SCALE: FULL DATE: 7-5-94 DRAWING NO. C-4017

DRAWING REVISION PAGE

SUBJECT: RM-89mm-400 CAP

DOC: C-4017

R.M.89 M.M./400 CAP

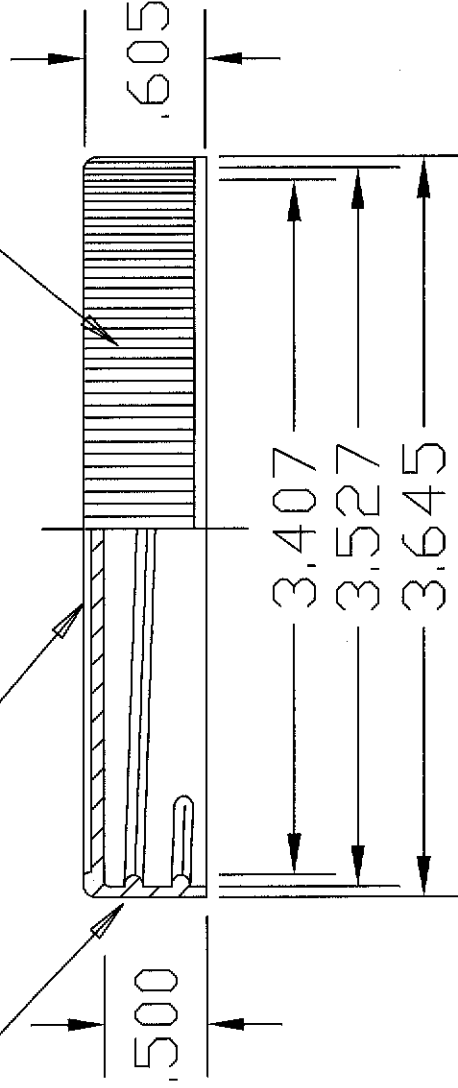
REV LEVEL	REV DATE	DESCRIPTION OF CHANGE
4	October 12, 2004	More stable measuring equipment had been implemented. Historical data collected has been reviewed and drawing update requires completion. Changed "A" from 3.630 to 3.645. Added weight tolerance of +/- 2.5 grams to include all color variations. No tool changes have been done.

"T"	"E"	"H"	"A"	"B"
3.527	3.407	.500	3.645	.605
MATERIAL: POLYPROPYLENE				
WEIGHT: 13.0 GRAMS + / - 2.5 grams
